Access Audit Site Report

Prepared By
WT Group

Possum Kingdom State Park
3901 St Park Rd 33
Caddo, TX 76429
Accessibility Evaluation
Inspection Date: 01/18/2022
Inspectors: Tanya Scheibe

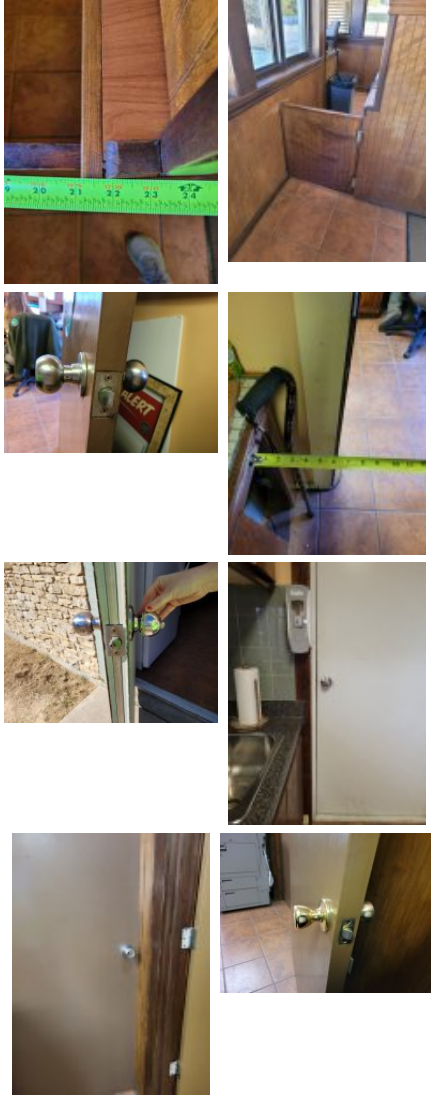
Finding Number	Area Description	Lat/Long	Finding	As Built	Recommendation	Citation	Photos	Figure
8	Headquarters Building: HQ - Parking	[32.8736304 , -98.5593306]	The handrail does not have a compliant extension at the bottom of the stair flight. At the bottom of a stair flight, handrails shall extend at the slope of the stair flight for a horizontal distance at least equal to one tread depth beyond the last riser nosing. Extension shall return to a wall, guard, or the landing surface, or shall be continuous to the handrail of an adjacent stair flight.	HQ entry stairway - lack bottom extension - 16" tread depth on step, 9" continuous hand rail	Install handrails on both sides of stairway, mounted 34" to 38" aff with top and bottom extensions and having a 1.25" – 2" in diameter, or a non-circular grip that has a perimeter dimension of 4"- 6.25" max with a min gap of 1.5" between handrail and wall Provide required extensions at the bottom of the stairway	2015 ABAAS Section: 505.10.3 2012 TAS Section: 505.10.3 2010 ADAS Section: 505.10.3		 <p>Note: X = tread depth Figure 505.10.3 Bottom Handrail Extension at Stairs</p>

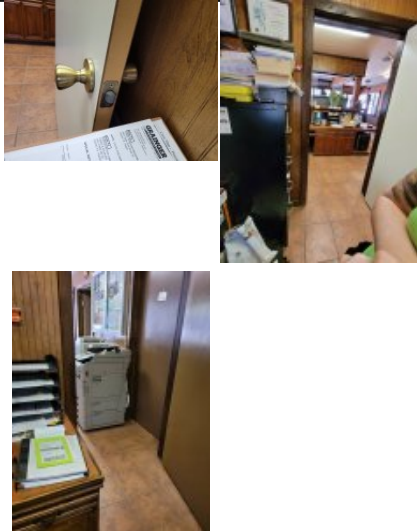
Finding Number	Area Description	Lat/Long	Finding	As Built	Recommendation	Citation	Photos	Figure
9	Headquarters Building: HQ - Parking	[32.8736586 , -98.559364 1]	Stairways must have handrails on both sides. Handrails and their extensions must be between 34 inches and 38 inches above the stair nosing or ground. The top handrails shall extend a minimum of 12 inches beyond the top nosing and shall be parallel with the floor or ground surface. At the bottom of a stair flight, handrails shall extend at the slope of the stair flight for a horizontal distance at least equal to one tread depth beyond the last riser nosing. Extension shall return to a wall, guard, or the landing surface, or shall be continuous to the handrail of an adjacent stair flight. The orientation of at least one handrail, including the extension, shall be in the direction of the run of the stair and perpendicular to the direction of the stair nosing. Handrail gripping surfaces with a circular cross section shall have an outside diameter of 1-1/4 inches minimum and 2 inches maximum. Handrail gripping surfaces with a non-circular cross section shall have a perimeter dimension of 4 inches minimum and 6 1/4 inches maximum, and a cross-section dimension of 2-1/4 inches maximum. The hand grip portion of handrails shall have a smooth surface with no sharp corners. Gripping surfaces (top or sides) shall be uninterrupted by newel posts, other construction elements or obstructions. Any wall or other surface adjacent to the handrail shall be free of sharp or abrasive elements. Handrails projecting from a wall shall have a space of 1-1/2 inches minimum between the wall and the handrail.	HQ entry stairway - hand rails only installed on 1 side of staircase	Install handrails on both sides of stairway, mounted 34" to 38" aff with top and bottom extensions and having a 1.25" – 2" in diameter, or a non-circular grip that has a perimeter dimension of 4"- 6.25" max with a min gap of 1.5" between handrail and wall	2015 ABAAS Section: 505.2 2012 TAS Section: 505.2 2010 ADAS Section: 505.2

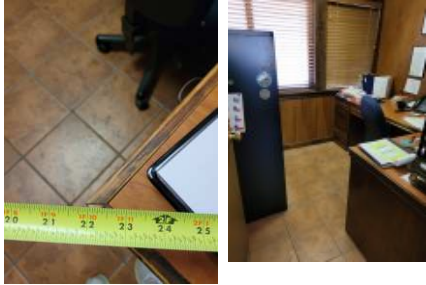
Finding Number	Area Description	Lat/Long	Finding	As Built	Recommendation	Citation	Photos	Figure
10	Headquarters Building: HQ - Parking	[32.8736327, -98.5594714], [32.873689, -98.5594862]	The accessible route of travel on the accessible route contains cross slopes greater than 2%. Cross slopes shall not exceed one unit vertical in 48 units horizontal (2-percent slope).	Headquarters sloped entry - 2.8% at bottom, 5.3% on exit side sidewalk parallel to access aisle, 4.6% in-between stalls in lot	Correct or repair cross slope along AR to max 2.08%	2015 ABAAS Section: 403.3 2012 TAS Section: 403.3 2010 ADAS Section: 403.3		
11	Headquarters Building: HQ - Parking	[32.8736191, -98.5594915]	The curb ramp slope exceeds the maximum running slope (Parallel to the direction of travel) allowable of 8.33%. Curb ramps should have the least possible slope but in no case more than 8.3% (1:12).	to enter the Headquarters building - you must use curb ramp to enter from parking lot - 20.5% slope	Correct curb ramp running slope to max 8.33%	2015 ABAAS Section: 406.1 2012 TAS Section: 406.1 2010 ADAS Section: 406.1

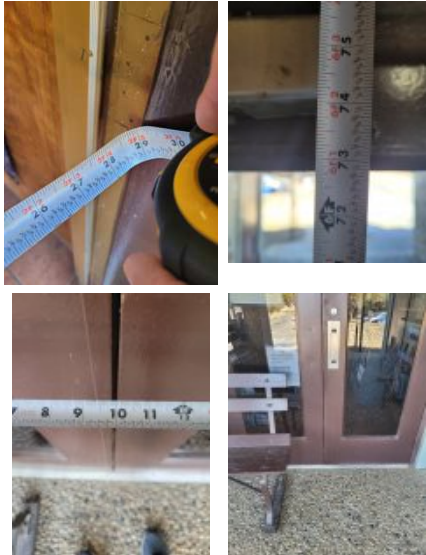
Finding Number	Area Description	Lat/Long	Finding	As Built	Recommendation	Citation	Photos	Figure
14	Headquarters Building: HQ - Parking	[32.8736608 , -98.559513] [32.8737002 , -98.559443 3]	The cross slopes (narrow dimension) and/or running slopes (long dimension) of the access aisle exceeds 2%. The running slope and the cross slope in an accessible parking stall and the access aisle must not exceed 2%.	entry side - stall 4.2%, access aisle - 3.6%, exit side - access aisle 6.5%, stall - 4.7%	Repair or correct slope of parking space and access aisle to max 2.08% in any direction	2015 ABAAS Section: 502.4 2012 TAS Section: 502.4 2010 ADAS Section: 502.4

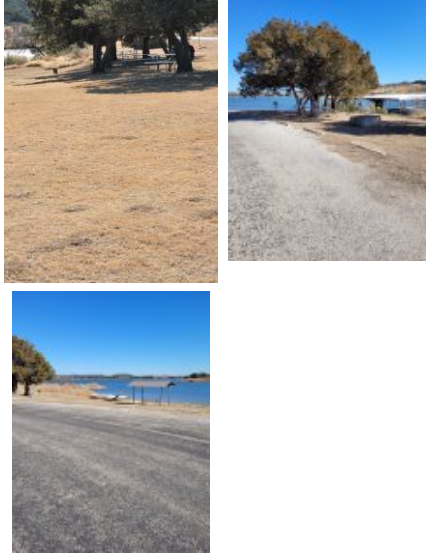
38	Headquarters Building: HQ - Restroom	[32.8736, -98.55934]	The mirror is mounted too high. Mirrors must have the bottom edge of the reflecting surface a maximum of 40 inches above the floor if above a sink or counter. Mirrors not located above lavatories or countertops shall be installed with the bottom edge of the reflecting surface 35 inches maximum above the finish floor or ground.	Men's restroom - reflective surface mounted 42.25" above finished floor	Lower mirror so reflective surface is max 40" aff Lower mirror not over a sink or counter to max 35" aff to the reflective surface	2015 ABAAS Section: 603.3 2012 TAS Section: 603.3 2010 ADAS Section: 603.3		
39	Headquarters Building: HQ - Restroom	[32.8736, -98.55934]	The water and drain pipes under the lavatory are not adequately insulated. Water supply and drain pipes under lavatories and sinks shall be insulated or otherwise configured to protect against contact. There shall be no sharp or abrasive surfaces under lavatories and sinks.	Men's restroom - sink pipe lacks insulation	Insulate exposed pipes under one sink	2015 ABAAS Section: 606.5 2012 TAS Section: 606.5 2010 ADAS Section: 606.5

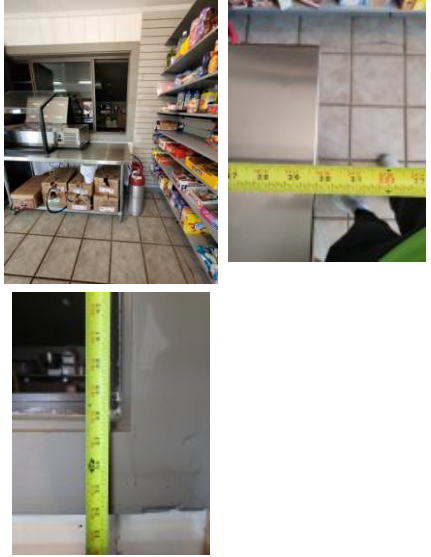
50	Possum Kingdom Store & Marina: Possum Kingdom Store & Marina - Parking and Exterior Accessible Route	[32.881412, -98.5607482]	There is no accessible route to the grill areas, picnic table or canoe launch. At least one accessible route shall connect accessible buildings, accessible facilities, accessible elements, and accessible spaces that are on the same site.	day use area at Marina - 6 BBQ, 7 picnic tables and canoe launch	Create an accessible route with crushed stone or other outdoor material to two tables/grills and canoe launch.	2015 ABAAS Section: F206.2.2 2012 TAS Section: 206.2.2 2010 ADAS Section: 206.2.2

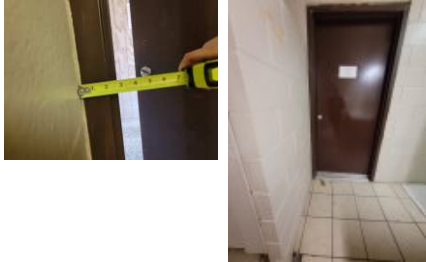
Finding Number	Area Description	Lat/Long	Finding	As Built	Recommendation	Citation	Photos	Figure
91	Lakeview Camping Area: Lakeview - Women's Restroom	[32.8800425 , -98.556767 8]	Knee clearance at 27 inches off the floor is not 8 inches minimum deep. The knee clearance, measured from the bottom of the apron or the outside bottom edge of the lavatory, must be 27 inches at a point located 8 inches back from the front edge and continuing to 11 inches minimum in depth at 9 inches above the floor. The top of the lavatory rim may be no higher than 34 inches.	Women's restroom - sink lacks knee clearance	Remove face board to provide 8" deep knee clearance.	2015 ABAAS Section: 306.3.1, 306.3.2, 306.3.3, 306.3.4 , 306.3.5 2012 TAS Section: 306.3.2, 306.3.3, 306.3.4, 306.3.5, 306.3.1 2010 ADAS Section: 306.3.3, 306.3.2, 306.3.4, 306.3.5, 306.3.1

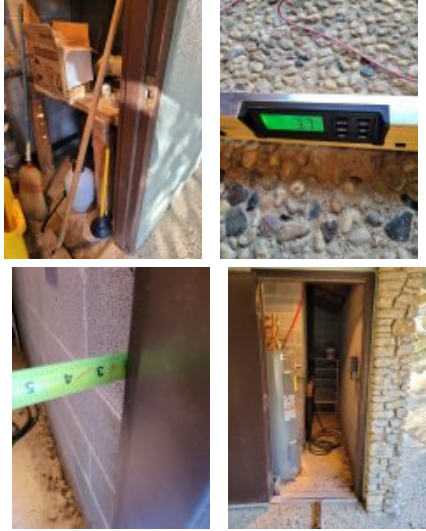
Finding Number	Area Description	Lat/Long	Finding	As Built	Recommendation	Citation	Photos	Figure
94	Lakeview Camping Area: Lakeview - Women's Restroom	[32.8800605 , -98.556786 5]	The stall door fails to comply with all of the door requirements. The stall door must be a minimum of 32" wide and have compliant hardware on both sides. The stall door must be self-closing.	Women's restroom - stall door has 28.5" width	Widen stall doors to 32" when opened to 90 degrees.	2015 ABAAS Section: 404.2.3, 404.2.7, 604.8.2.2 2012 TAS Section: 404.2.3, 404.2.7, 604.8.2.2 2010 ADAS Section: 404.2.3, 404.2.7, 604.8.2.2		
95	Lakeview Camping Area: Lakeview - Women's Restroom	[32.8800605 , -98.556775 8]	Grab bars shall comply with 609. A side-wall grab bar complying with 604.5.1 shall be provided on both sides of the compartment. The space between the wall and the grab bar shall be 1½ inches (38 mm). The space between the grab bar and projecting objects below and at the ends shall be 1½ inches (38 mm) minimum. The space between the grab bar and projecting objects above shall be 12 inches (305 mm) minimum. Grab bars shall be installed in a horizontal position, 33 inches (840 mm) minimum and 36 inches (915 mm) maximum above the finish floor measured to the top of the gripping surface, except that at water closets for children's use complying with 604.9, grab bars shall be installed in a horizontal position 18 inches (455 mm) minimum and 27 inches (685 mm) max	Women's restroom - both side grab bars are mounted 36" from rear wall	Replace or add side grab bars with a 42" long grab bar, mounted max 12" from the rear wall at the close end and min 54" on the far end and 33" to 36" aff.	2015 ABAAS Section: 604.8.2.3, 609.3, 609.4 2012 TAS Section: 609.4, 609.3, 604.8.2.3 2010 ADAS Section: 609.3, 609.4, 604.8.2.3

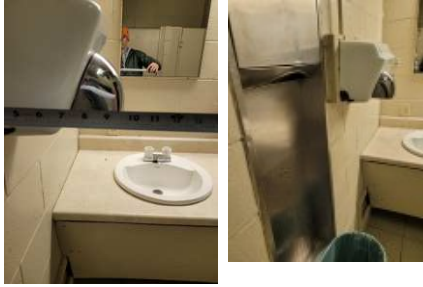
102	Lakeview Camping Area: Lakeview - Women's Restroom	[32.8800605 , -98.556765 1]	There are no accessible bathing or shower facilities. Where facilities for bathing are provided for the public, clients or employees, including showers or bathtubs, at least one shower or bathtub and support facilities such as lockers, and not less than 1 percent of all facilities, shall be accessible.	Women's restroom - lacks accessible shower	Create an accessible shower in locker/bathing room	2015 ABAAS Section: F213.3.6 2012 TAS Section: 213.3.6 2010 ADAS Section: 213.3.6

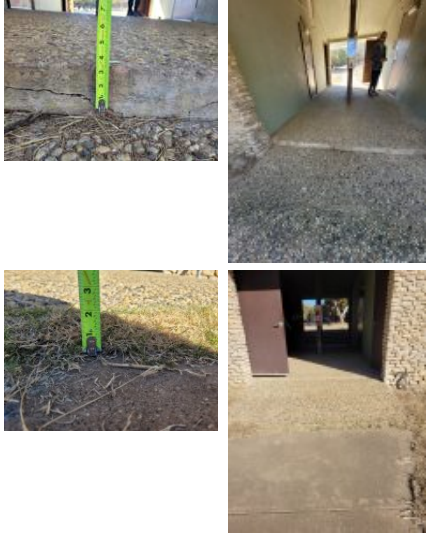
Finding Number	Area Description	Lat/Long	Finding	As Built	Recommendation	Citation	Photos	Figure
108	Lakeview Camping Area: Lakeview- Men's Restroom	[32.880056, -98.556770 4]	The faucet controls require twisting of the wrist. Faucet controls and operating mechanisms shall be operable with one hand and shall not require tight grasping, pinching or twisting of the wrist. The force required to activate controls shall be no greater than 5 lb. Lever-operated, push-type and electronically controlled mechanisms are examples of acceptable designs. Self-closing valves are allowed if the faucet remains open for at least 10 seconds.	Men's restroom - knob controls require a grasp and twist	Replace faucet controls with lever controls	2015 ABAAS Section: 606.4 2012 TAS Section: 606.4 2010 ADAS Section: 606.4		
109	Lakeview Camping Area: Lakeview- Men's Restroom	[32.8800538, -98.556773 1]	Where a high forward reach is over an obstruction, the clear floor space shall extend beneath the element for a distance not less than the required reach depth over the obstruction. The high forward reach shall be 48 inches (1220 mm) maximum where the reach depth is 20 inches (510 mm) maximum. Where the reach depth exceeds 20 inches (510 mm), the high forward reach shall be 44 inches (1120 mm) maximum and the reach depth shall be 25 inches (635 mm) maximum. Where a clear floor or ground space allows a parallel approach to an element and the high side reach is over an obstruction, the height of the obstruction shall be 34 inches (865 mm) maximum and the depth of the obstruction shall be 24 inches (610 mm) maximum. The high side reach shall be 48 inches (1220 mm) maximum for a reach depth of 10 inches (255 mm) maximum. Where the reach depth exceeds 10 inches (255 mm), the high side reach shall be 46 inches (1170 mm) maximum for a reach depth of 24 inches (610 mm) maximum.	Men's restroom - hand dryer installed 51" above finished floor	Lower operating mechanisms to max 48" aff to highest operable part. In the alternative, leave as is citing safe harbor.	2015 ABAAS Section: 308.2.1, 308.3.2 2012 TAS Section: 308.2.1, 308.3.2 2010 ADAS Section: 308.2.1, 308.3.2

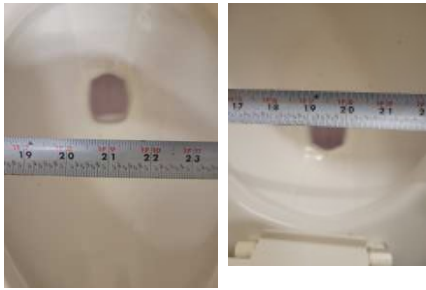
Finding Number	Area Description	Lat/Long	Finding	As Built	Recommendation	Citation	Photos	Figure
122	Shady Grove Camping Area (Water & Electric): Shady Grove - Parking and Exterior Accessible Route	[32.8795132, -98.5548151]	There is a gap spaced greater than a 1/2 inch. Openings in floor or ground surfaces shall not allow passage of a sphere more than 1/2 inch diameter. Elongated openings shall be placed so that the long dimension is perpendicular to the dominant direction of travel.	.75" gap at closet side entry to restroom at Shady Grove restroom	Correct or fill gaps to be max .5"	2015 ABAAS Section: 302.3 2012 TAS Section: 302.3 2010 ADAS Section: 302.3		
123	Shady Grove Camping Area (Water & Electric): Shady Grove - Parking and Exterior Accessible Route	[32.8795132, -98.5548151]	The walkway contains abrupt vertical edges and/or variations over a 1/4 inch. 1/4 inch is the maximum vertical rise. Changes in level between 1/4 inch and 1/2 inch must be beveled at 1:2 or less. Changes in level greater than 1/2 inch must be by way of a ramp.	3.5" change in elevation on parking side at Shady Grove, non stair side - 2" change in elevation at entry to grass path	Repair, bevel or ramp CIL along route	2012 TAS Section: 303.2, 303.3 2010 ADAS Section: 303.2, 303.3

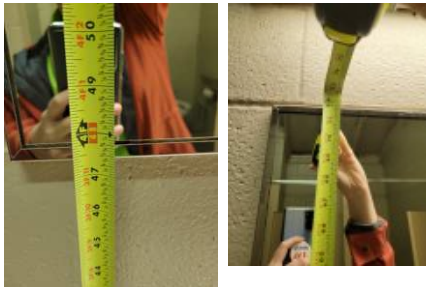
132	Shady Grove Camping Area (Water & Electric): Shady Grove - Men's Restroom	[32.879556, -98.5548178]	There are not enough accessible toilet compartments. The room contains toilet compartments. A minimum of 1 must be wheelchair accessible .	Men's restroom - 2 of 2 stalls are not accessible	Create a wheelchair accessible stall with grab bars and fixtures mounted in correct locations and at correct heights.	2015 ABAAS Section: F213.3.1 2012 TAS Section: 213.3.1 2010 ADAS Section: 213.3.1

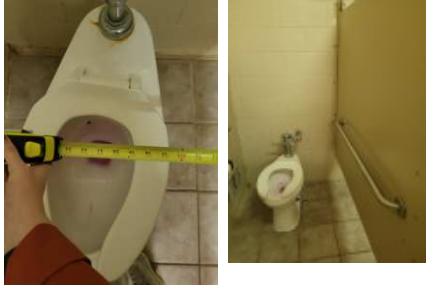
138	Shady Grove Camping Area (Water & Electric): Shady Grove - Men's Restroom	[32.8795424, -98.554815 1]	An item or items project more than 4 inches into the circulation path. Wall-mounted objects that have leading edges between 27 inches and 80 inches from the floor must not project more than 4 inches into the circulation path. Protruding objects that extend to the floor or within 27 inches of the floor are cane detectable and are therefore not hazardous. Where it is necessary or desirable to have objects protrude from the wall, a manner of cane detection must be provided.	Men's restroom - hand dryer projects 9.75" into circulation path	Relocate protruding objects or place cane detectable warning or bollard at foot of item.	2015 ABAAS Section: 307.2 2012 TAS Section: 307.2 2010 ADAS Section: 307.2

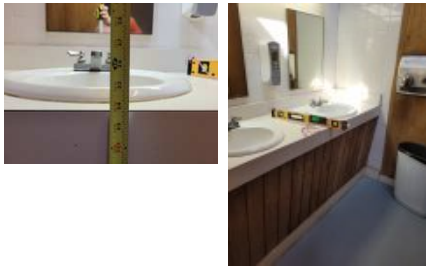
Finding Number	Area Description	Lat/Long	Finding	As Built	Recommendation	Citation	Photos	Figure
178	Chaparral Trail Camping Area (Water): Chaparral Trail - North Men's Restrooms	[32.8782247 , -98.5520927]	The restroom sign does not comply with one or more applicable requirements for the location, height, and properties of the sign.	Men's restroom - signage is not compliant	Acquire and mount signage, including Braille and access symbol mounted on wall, latch side of door, 48" to baseline of lowest character and 60" to baseline of highest character.	2015 ABAAS Section: F216.2, 703.1, 703.2, 703.5, 703.6 2012 TAS Section: 216.2, 703.1, 703.2, 703.5, 703.6 2010 ADAS Section: 216.2, 703.1, 703.2, 703.5, 703.6		
179	Chaparral Trail Camping Area (Water): Chaparral Trail - North Men's Restrooms	[32.8782292 , -98.5520846]	The mirror is mounted too high. Mirrors must have the bottom edge of the reflecting surface a maximum of 40 inches above the floor if above a sink or counter. Mirrors not located above lavatories or countertops shall be installed with the bottom edge of the reflecting surface 35 inches maximum above the finish floor or ground.	Men's restroom - bottom edge of reflective surface is mounted 42" above finished floor	Lower mirror so reflective surface is max 40" aff.	2015 ABAAS Section: 603.3 2012 TAS Section: 603.3 2010 ADAS Section: 603.3

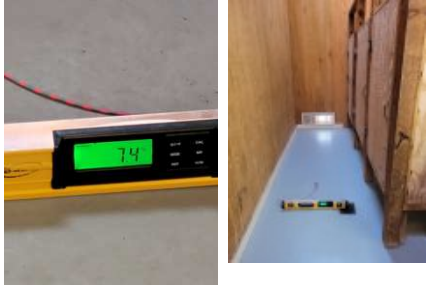
187	Chaparral Trail Camping Area (Water): Chaparral Trail - North Men's Restrooms	[32.8782269, -98.5521047]	The side grab bars are not in the correct location. Grab bars on the side wall must be installed so that the end closest to the rear wall is maximum 12" from the rear wall. The end furthest from the rear wall must be mounted minimum 54" from the rear wall.	Men's restroom - side grab bar is installed 52" from back wall	Remount side grab bar to max 12" from the rear wall at the close end and min 54" on the far end, and 33" to 36" aff	2015 ABAAS Section: 604.5.1 2012 TAS Section: 604.5.1 2010 ADAS Section: 604.5.1

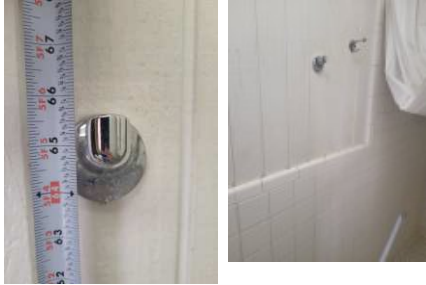
Finding Number	Area Description	Lat/Long	Finding	As Built	Recommendation	Citation	Photos	Figure
191	Chaparral Trail Camping Area (Water): Chaparral Trail - North Women's Restrooms	[32.8782258 , -98.5521101]	The restroom sign does not comply with one or more applicable requirements for the location, height, and properties of the sign.	Women's restroom - 75" to bottom of sign, signage is not compliant	Acquire and mount signage, including Braille and access symbol mounted on wall, latch side of door, 48" to baseline of lowest character and 60" to baseline of highest character	2015 ABAAS Section: F216.2, 703.1, 703.2, 703.5, 703.6 2012 TAS Section: 216.2, 703.1, 703.2, 703.5, 703.6 2010 ADAS Section: 216.2, 703.1, 703.2, 703.5, 703.6		
192	Chaparral Trail Camping Area (Water): Chaparral Trail - North Women's Restrooms	[32.8782269 , -98.552098]	The mirror is mounted too high. Mirrors must have the bottom edge of the reflecting surface a maximum of 40 inches above the floor if above a sink or counter. Mirrors not located above lavatories or countertops shall be installed with the bottom edge of the reflecting surface 35 inches maximum above the finish floor or ground.	Women's restroom - mirror mounted 40.5" above finished floor	Lower mirror so reflective surface is max 40" aff	2015 ABAAS Section: 603.3 2012 TAS Section: 603.3 2010 ADAS Section: 603.3

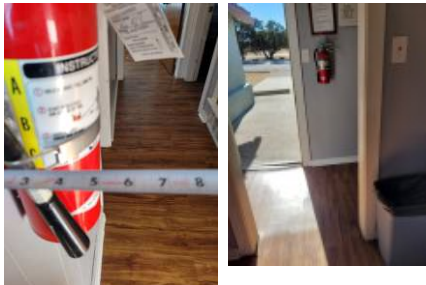
Finding Number	Area Description	Lat/Long	Finding	As Built	Recommendation	Citation	Photos	Figure
259	Spanish Oaks Camping Area: Spanish Oak - Cabin 1	[32.8820518 , -98.561829 1]	Knee clearance at 27 inches off the floor is not 8 inches minimum deep. The knee clearance, measured from the bottom of the apron or the outside bottom edge of the lavatory, must be 27 inches at a point located 8 inches back from the front edge and continuing to 11 inches minimum in depth at 9 inches above the floor. The top of the lavatory rim may be no higher than 34 inches.	Cabin 1 restroom - lacks knee clearance at sink	Remove face board to provide 8" deep knee clearance.	2015 ABAAS Section: 306.3.1, 306.3.2, 306.3.3, 306.3.4 , 306.3.5 2012 TAS Section: 306.3.2, 306.3.3, 306.3.4, 306.3.5, 306.3.1 2010 ADAS Section: 306.3.3, 306.3.2, 306.3.4, 306.3.5, 306.3.1		
260	Spanish Oaks Camping Area: Spanish Oak - Cabin 1	[32.8820585 , -98.561825 1]	The bench is not deep enough or long enough or is missing. Benches shall be provided having seats that are 42 inches long minimum and 20 inches deep minimum and 24 inches deep maximum. The bench shall provide for back support or shall be affixed to a wall. Back support shall be 42 inches (1065 mm) long minimum and shall extend from a point 2 inches (51 mm) maximum above the seat surface to a point 18 inches (455 mm) minimum above the seat surface. Back support shall be 2½ inches (64 mm) maximum from the rear edge of the seat measured horizontally. The top of the bench seat surface shall be 17 inches (430 mm) minimum and 19 inches (485 mm) maximum above the finish floor or ground. Clear floor or ground space complying with 305 shall be provided and shall be positioned at the end of the bench seat and parallel to the short axis of the bench	Cabin 1 restroom - lacks bench at shower area	Acquire and install bench in dressing area having a seat depth of 20" to 24" deep, 42" long, affixed to the wall or having a back and mounted 17" to 19" AFF and provide required clear floor space on the short axis of the bench.	2012 TAS Section: 903.4, 903.2, 903.3, 903.5 2010 ADAS Section: 903.4, 903.2, 903.3, 903.5

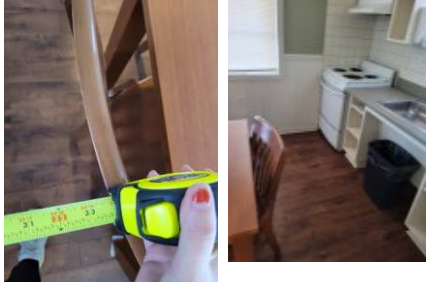
265	Spanish Oaks Camping Area: Spanish Oaks - Lodge	[32.8821013 , -98.5606006]	The operable part is positioned too high for either a side or front approach. Where a clear floor or ground space allows a parallel approach to an element and the side reach is unobstructed, the high side reach shall be 48 inches maximum and the low side reach shall be 15 inches minimum above the finish floor or ground. Where a forward reach is unobstructed, the high forward reach shall be 48 inches maximum and the low forward reach shall be 15 inches minimum above the finish floor or ground.	Lodge - light switches installed at 51.25" and 51.5" above finished floor	Remount operable parts to be in reach range of 15" min to 48" max. In the alternative, leave as is citing safe harbor.	2015 ABAAS Section: 308.1 2012 TAS Section: 308.1 2010 ADAS Section: 308.1		
266	Spanish Oaks Camping Area: Spanish Oaks - Lodge	[32.8821013 , -98.5606087]	The restroom is not compliant. The restroom does not have the required minimum clear floor space or maneuvering clearances for the toilet. The restroom does not have the required minimum clear floor space or maneuvering clearances for the lavatory. The entry door does not contain the required minimum maneuvering spaces on the pull/push sides. The entry door encroach into the required clear floor space for fixtures. Grab bars are missing and/or incorrectly installed. Accessories, such as toilet seat covers, paper towel holders, garbage cans, hand dryers, and mirrors are either too high or without clear floor space or both.	Lodge - restroom does not have accessible features	Create a compliant wheelchair accessible restroom and correct all features to be accessible if feasible.	2015 ABAAS Section: 603.1 2012 TAS Section: 603.1 2010 ADAS Section: 603.1

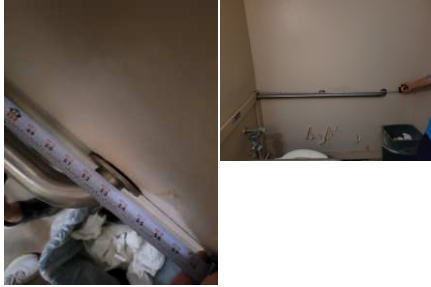
277	Spanish Oaks Camping Area: Spanish Oaks - Lodge	[32.8820968, -98.560606]	The threshold has a vertical change greater than 1/4 inch high. The threshold has a gap greater than 1/2 inch wide. The threshold at a doorway shall be no higher than 1/2 inch. Changes in level between 1/4 inch and 1/2 inch must be beveled at 1:2 or less. 1/4 inch is the maximum vertical rise. Hand-activated door opening hardware, handles, pulls, latches, locks, and other operating devices on accessible doors shall have a shape that is easy to grasp with one hand and does not require tight grasping, tight pinching or twisting of the wrist to operate. Hardware shall be 34 inches minimum and 48 inches maximum above the finish floor or ground.	Lodge - 4" gap due to threshold failing, 1.5" change in elevation, knob hardware	For all doors along the public circulation route, repair, bevel, or ramp CILs at door entries to max .25" For all doors along the public circulation fill gaps at door entries to max .5" For all doors along the public circulation route, repair, provide beveled threshold For all doors along the public circulation route, replace hardware with lever hardware or hardware operable without a tight pinch or grasp	2010 ADAS Section: 404.2.3, 404.2.7, 404.2.4, 404.2.11, 404.2.11 Exception
